SOBOBA BAND OF LUISEÑO INDIANS

REQUEST FOR PROPOSAL (RFP)

DONNA WAY OFFICES

ADDENDUM 4

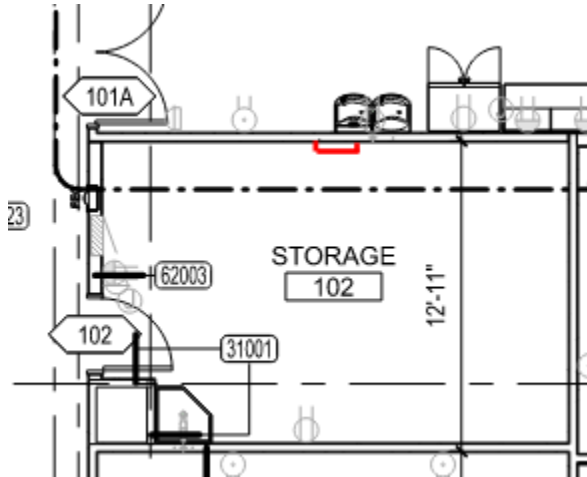
5. Electrical Room—clarification—the New Distribution Board, 'LR,' is the Contractor's responsibility. Only the existing switchboard, 'MSBE,' will be reused.
